ERRATA

Title: An Evaluation of the Status of Diablo Canyon Unit 1 With Respect to Reactor Pressure Vessel Condition Monitoring and Prediction
Part 2: Evaluation of Diablo Canyon Unit 1 Embrittlement
Date: 26 January 2024

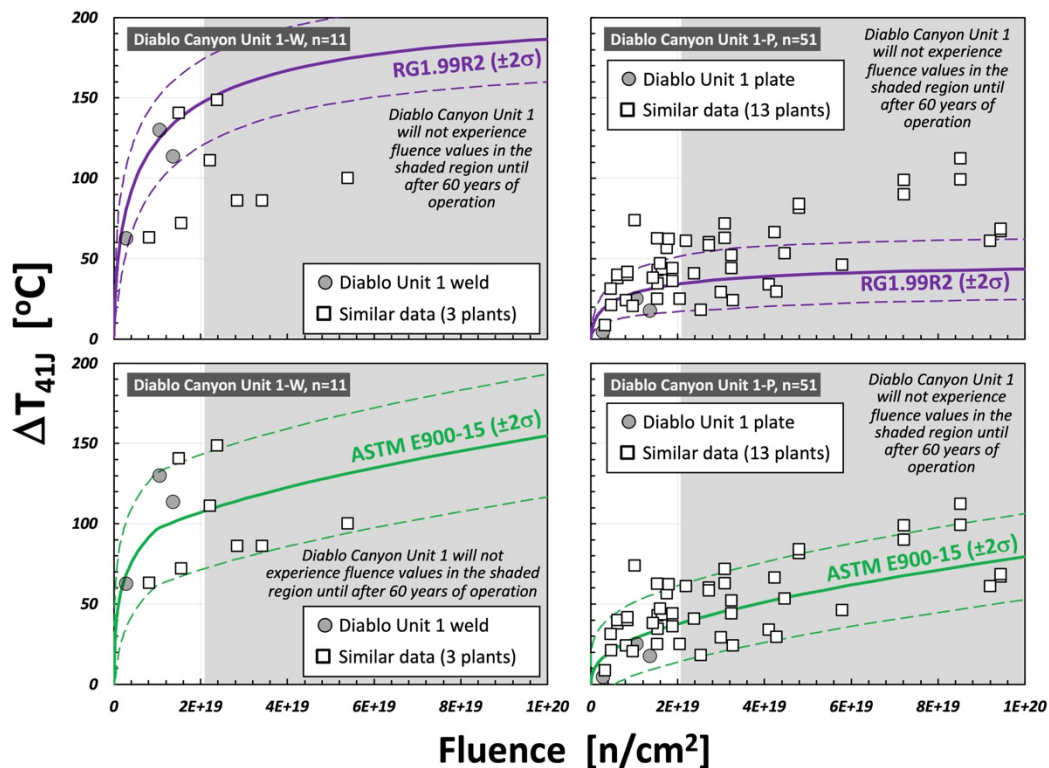
Correction: In the subject report the units on the vertical axis of Figure 8 (page 37) were stated incorrectly. The units were given as n/cm². The correct units are °C. The figure below shows the correct axis label.
